Access Compliance Report Public Rights-of-Way (Curb Ramps)

Intersection ID: 9634 Main Street: MALIBU_DR Cross Street: THE_PLAZA Location: NE

ADA ID: FA1AEFF9F271 Ramp Type: Perp Initial Pass/Fail: Fail Overall Compliance: No Severity Score: 21.25

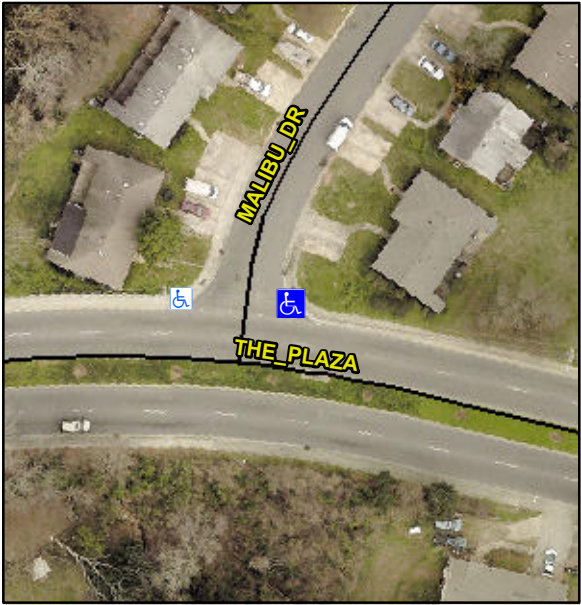
PROW/ADA:
Not Found, R304.5.1, R304.2.2

Compliance	Description	Data	Compliance	Description	Data
N/A	Ramp Length (in)	60.0	No	Ramp Slope (%)	9.1
No	Ramp Width (in)	47.5	Yes	Ramp XSlope (%)	0.6
N/A	Flare Type LT	N/A	N/A	Flare Type RT	N/A
N/A	Flare Slope LT (%)	N/A	N/A	Flare Slope RT (%)	N/A
N/A	Flare Traversable LT?	N/A	N/A	Flare Traversable RT?	N/A
N/A	Landing Length (in)	N/A	N/A	DWS Provided?	N/A
N/A	Landing Width (in)	N/A	N/A	DWS Contrast?	N/A
N/A	Landing Slope (%)	N/A	N/A	DWS Length (in)	N/A
N/A	Landing X Slope (%)	N/A	N/A	DWS Full Width?	N/A
N/A	Landing Curb? (Y/N)	N/A	N/A	DWS Offset (in)	N/A
N/A	Shared Landing?	N/A			
N/A	Gutter Ponding?	N/A	N/A	Gutter Slope (%)	N/A
N/A	Gutter Lip Ht (in)	1.0	N/A	Gutter X Slope (%)	N/A
N/A	Painted X Walk1?	No	N/A	Painted X Walk2?	N/A
	X Walk 1 Direction	To NW		X Walk 2 Direction	N/A
N/A	X Walk 1 Width (in)	N/A	N/A	X Walk 2 Width (in)	N/A
	X Walk 1 Slope (%)	0.1		X Walk 2 Slope (%)	N/A
	X Walk 1 X Slope (%)	1.2		X Walk 2 X Slope (%)	N/A

Possible Solutions:
Remove & Replace Entire Ramp.
